# County of Fairfax, Virginia

## STAFF REPORT ADDENDUM II

### SPECIAL EXCEPTION AMENDMENT APPLICATION SEA 94-P-040

**APPLICANT:** RP MRP Tysons, LLC

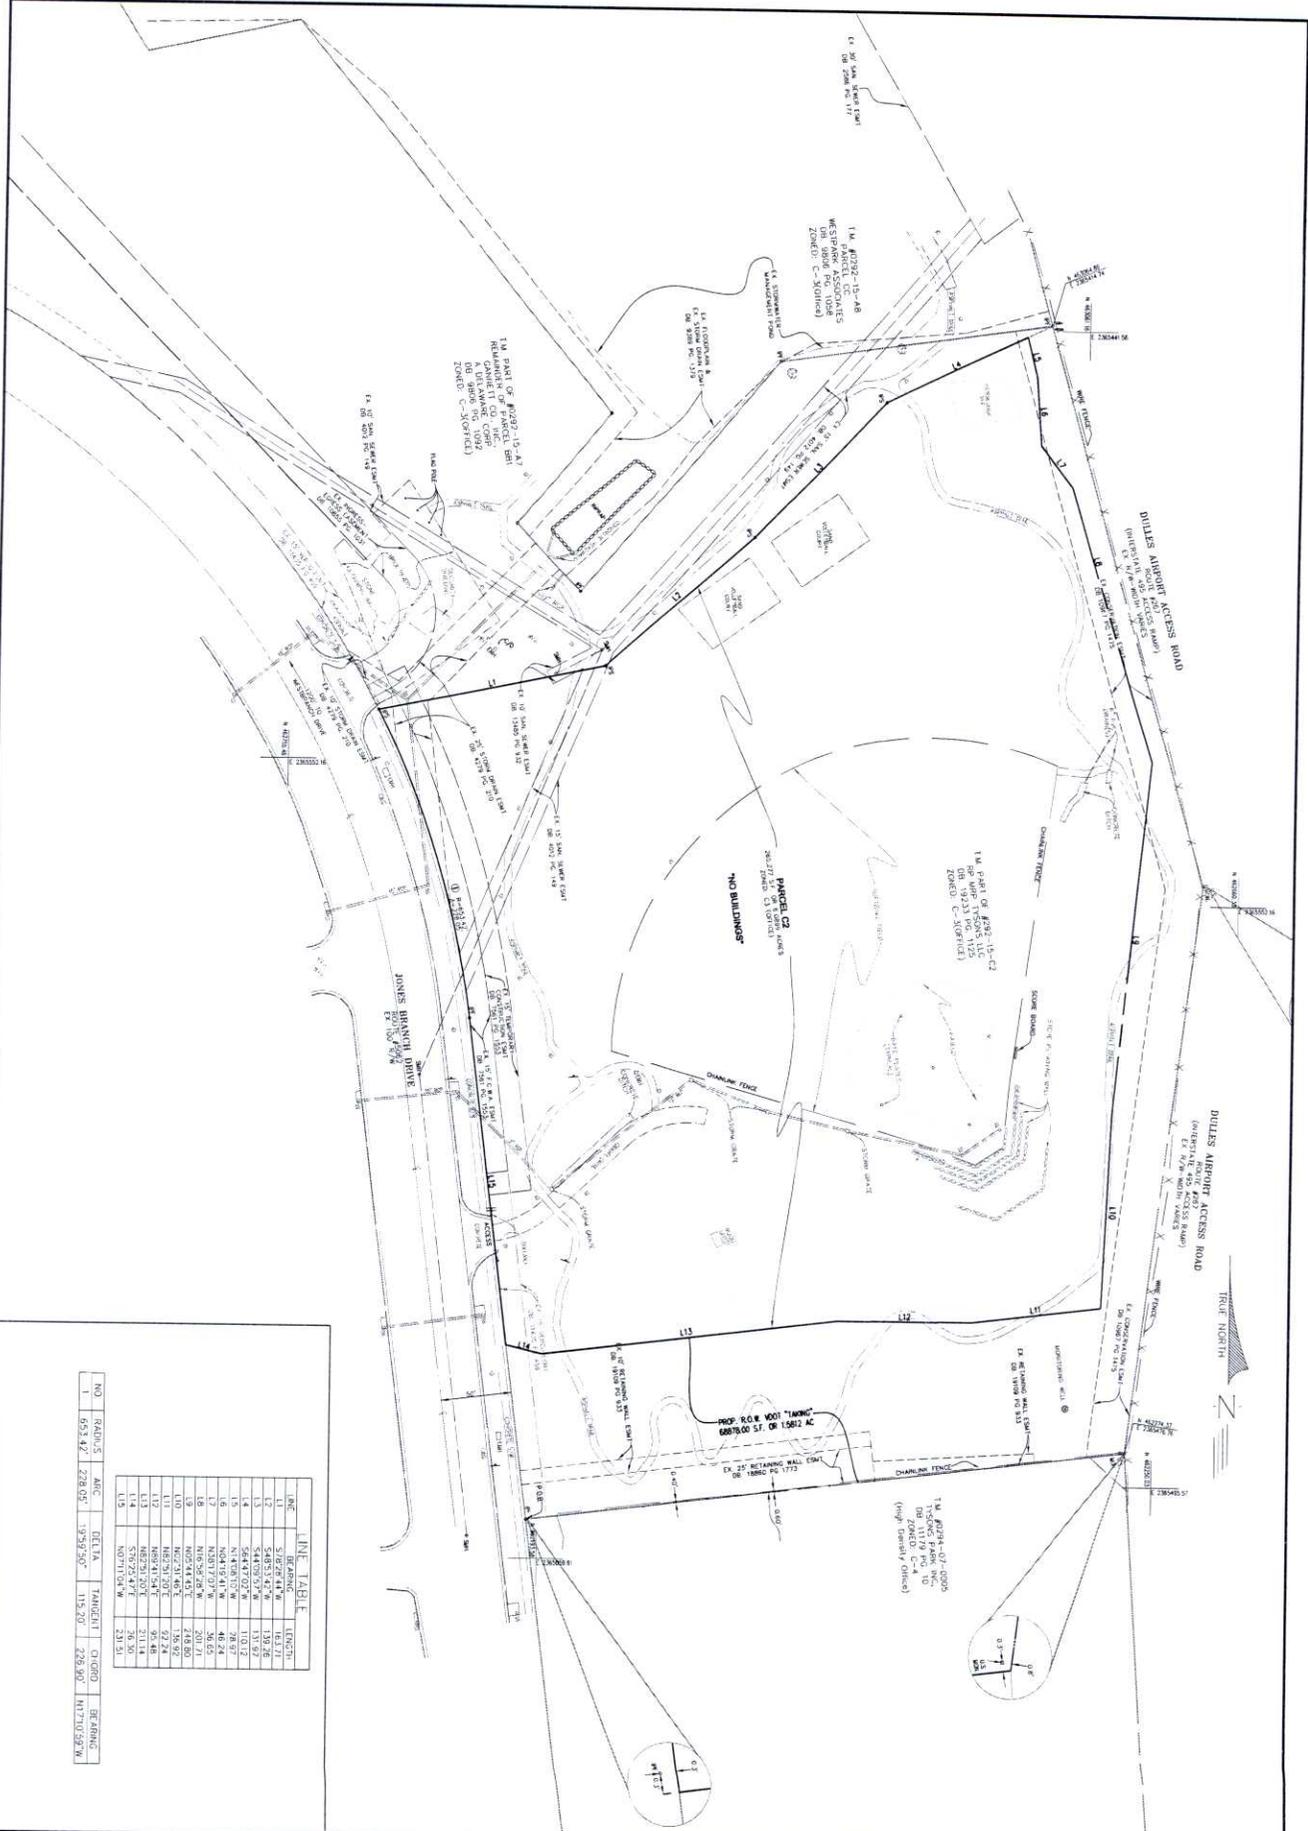
- 3. Comment:** The note on sheet 7 stating “the existing conservation easement to be vacated by VDOT with HOT lane construction” and the associated hatching is unclear as it appears the entire conservation easement is proposed to be vacated. In addition, areas identified as proposed R.O.W. dedication are unclear.

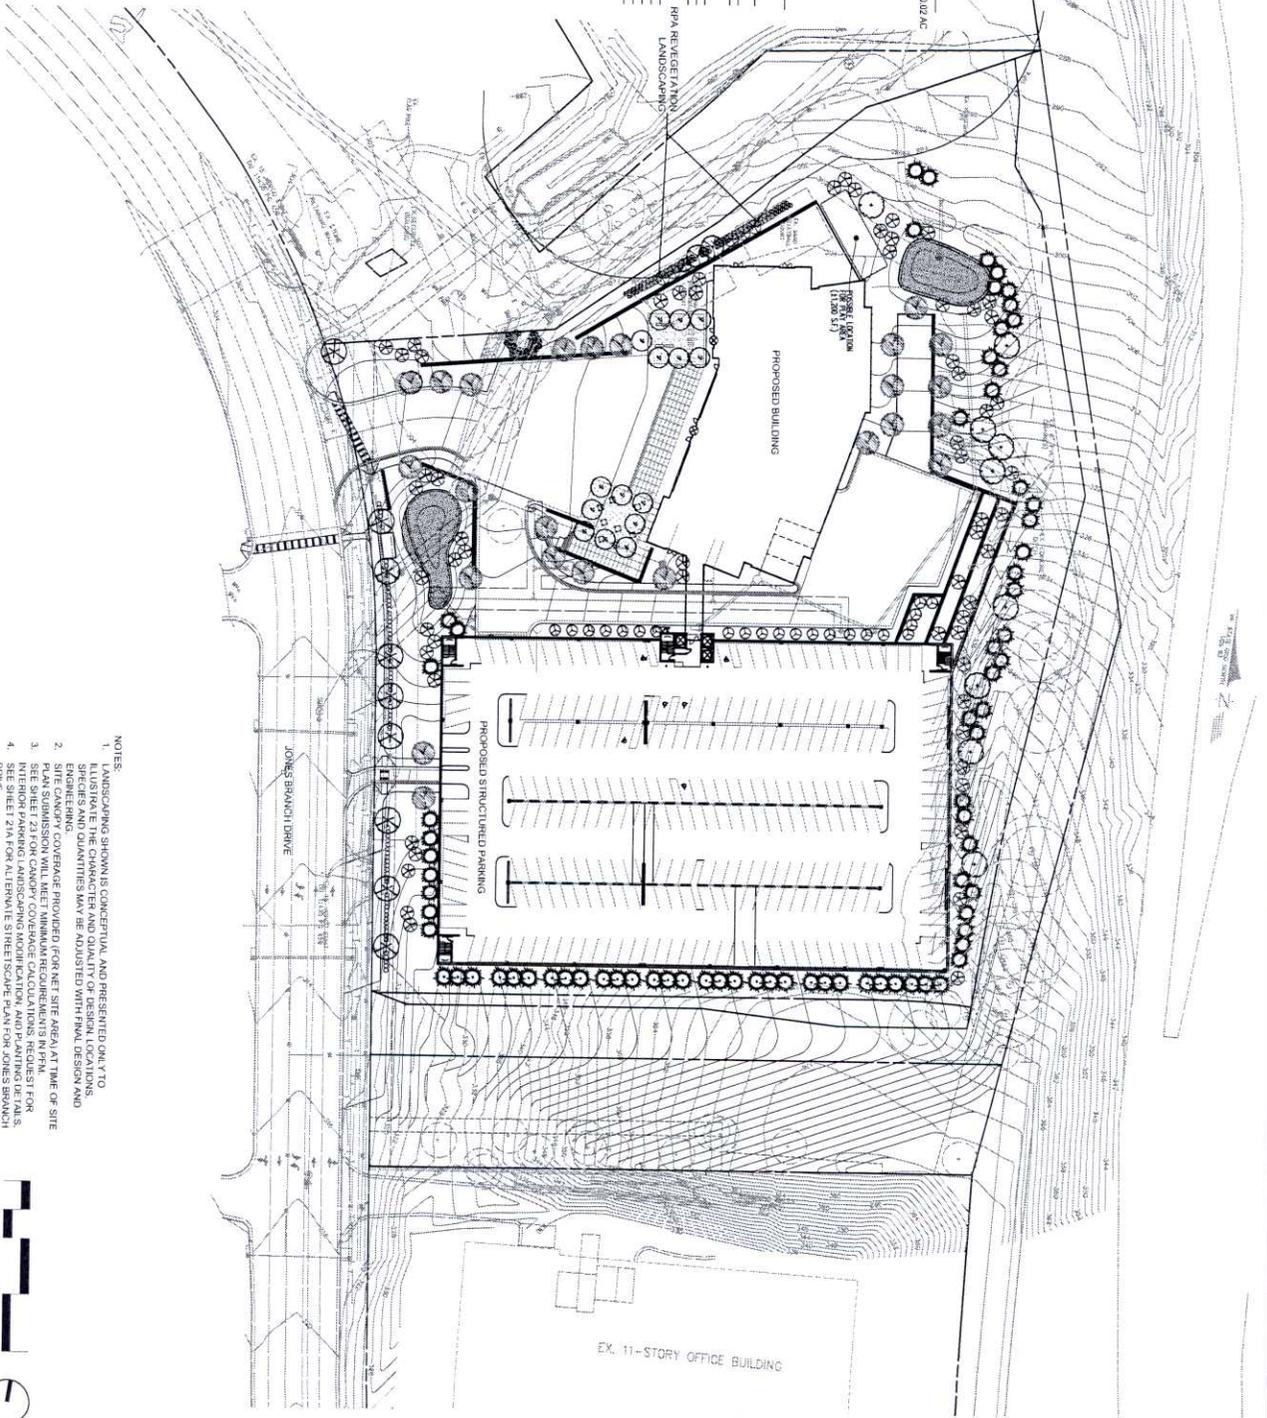
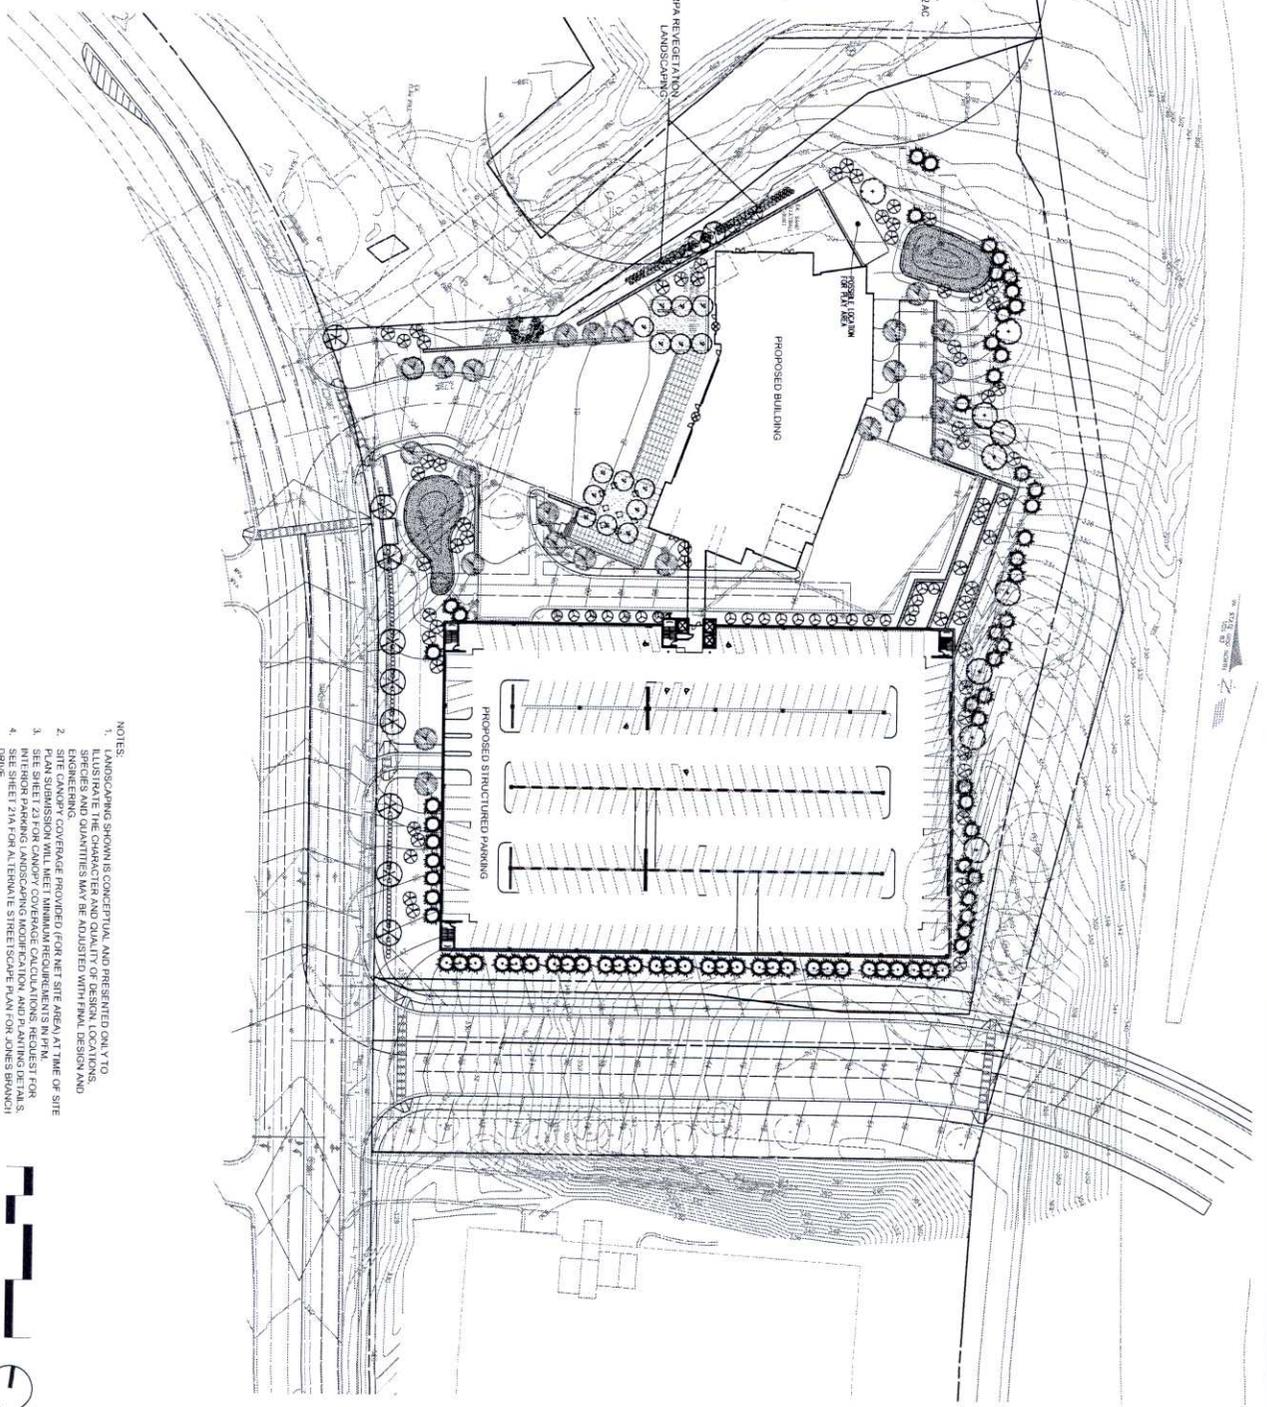
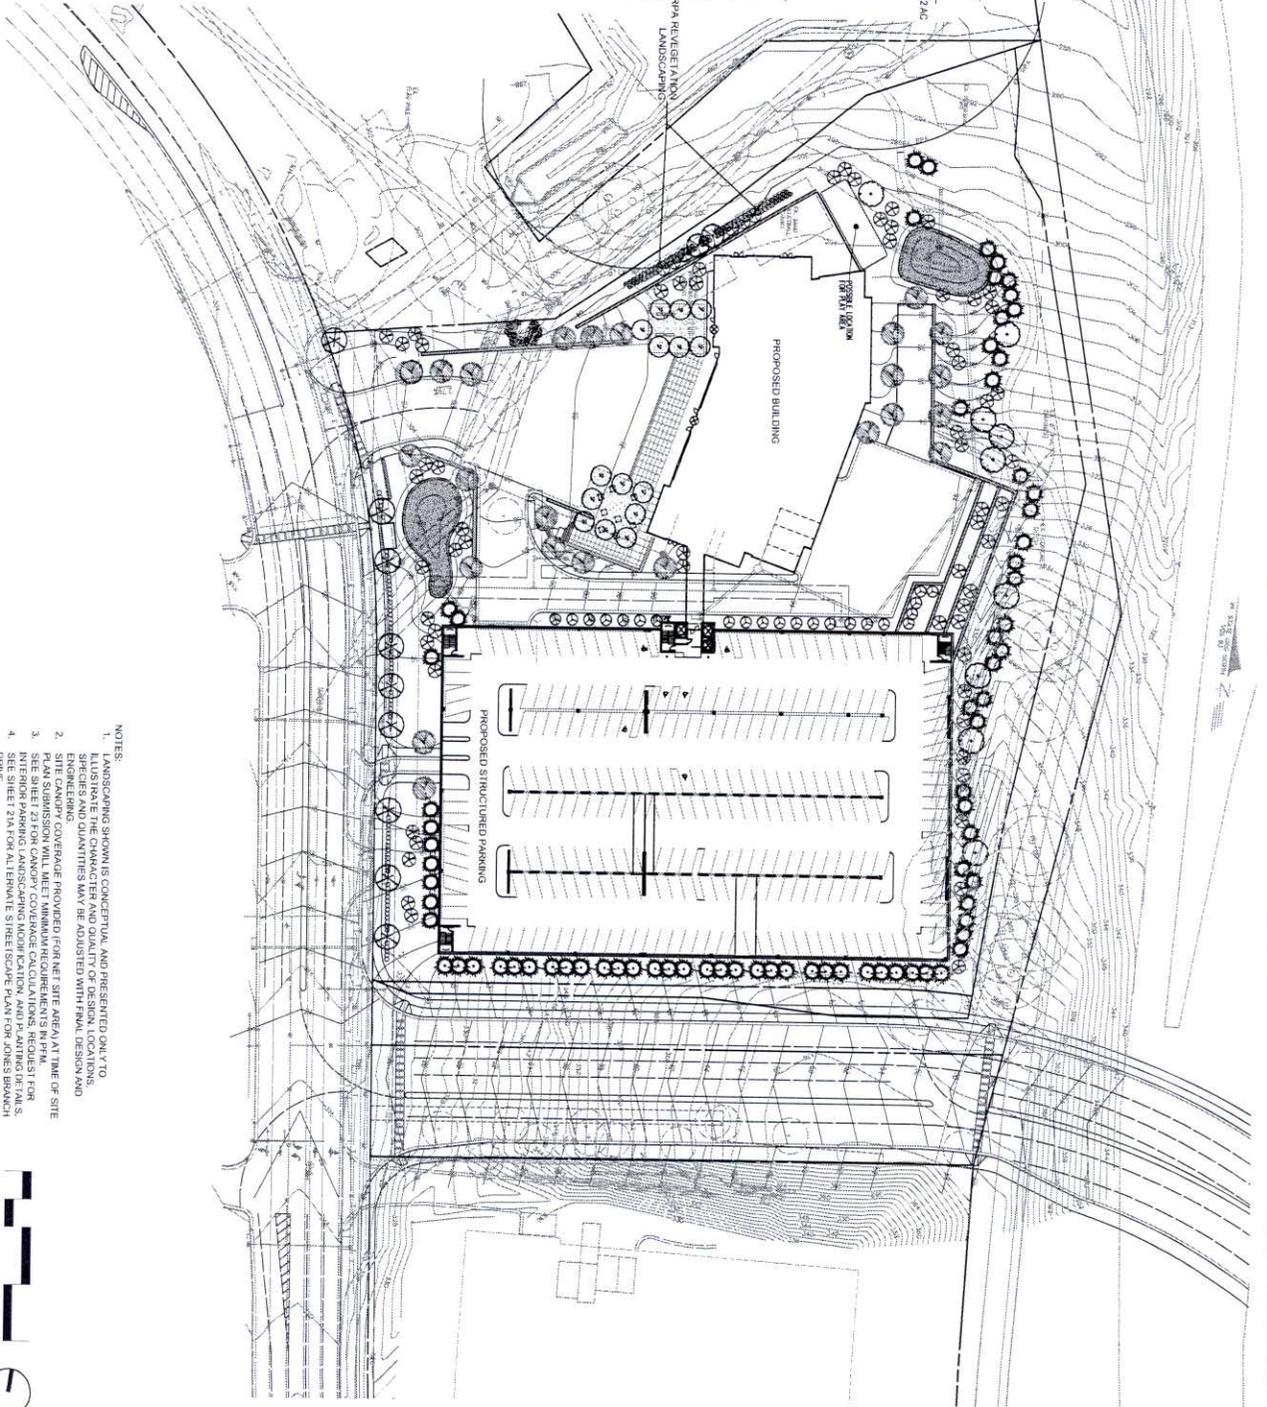
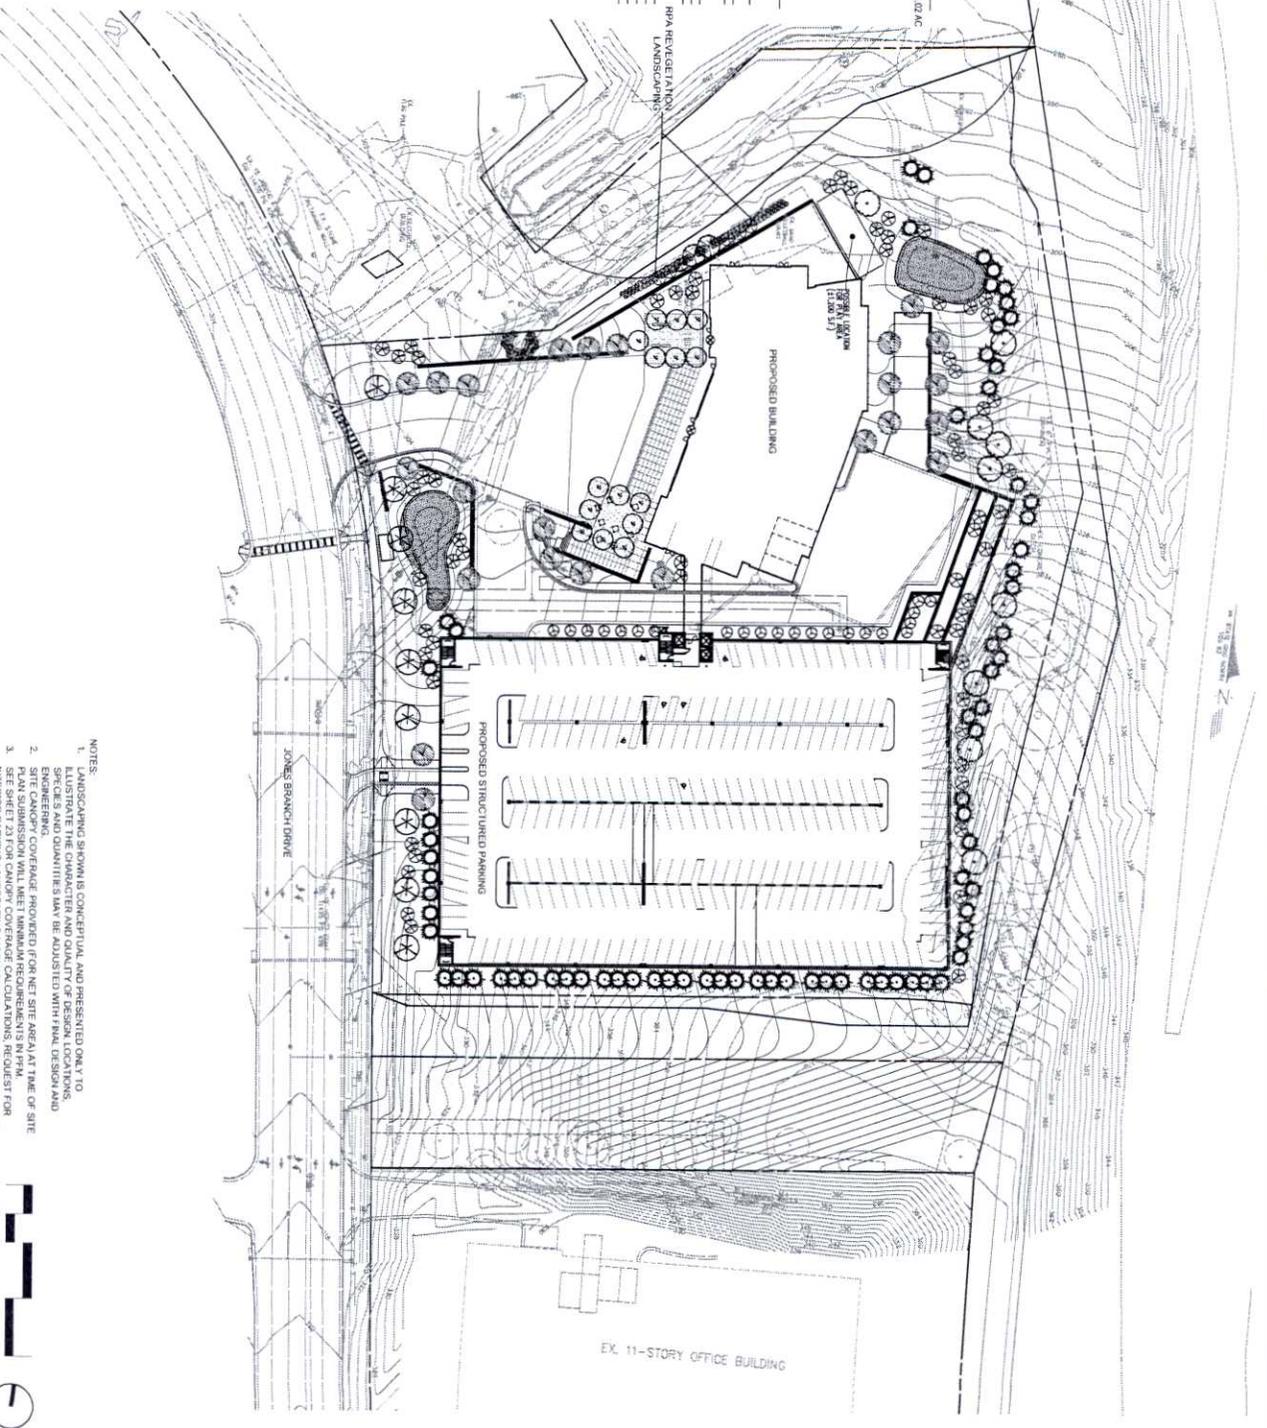
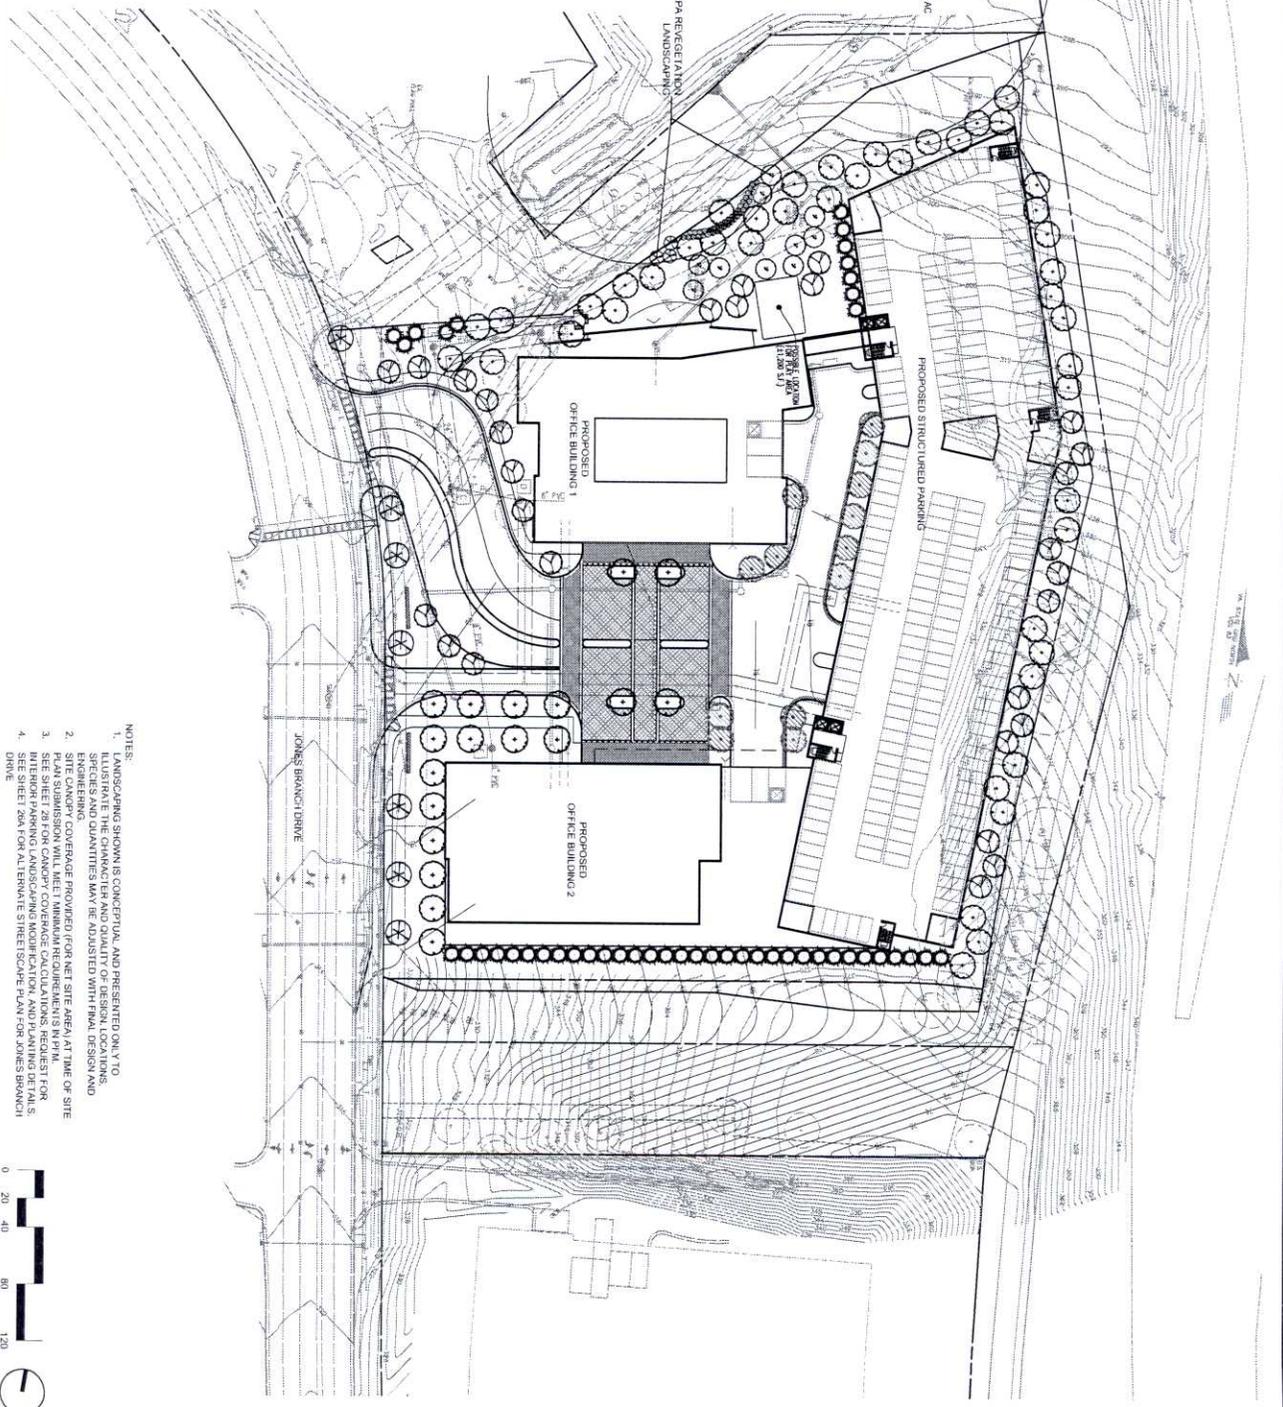
It should be noted that it appears from the SEA Plat that some of the plantings in Option 1 appear to be planted too close to a restrictive barrier. Staff advises the applicant that staff will review for adequate planting area to achieve landscaping sustainability during site plan review.
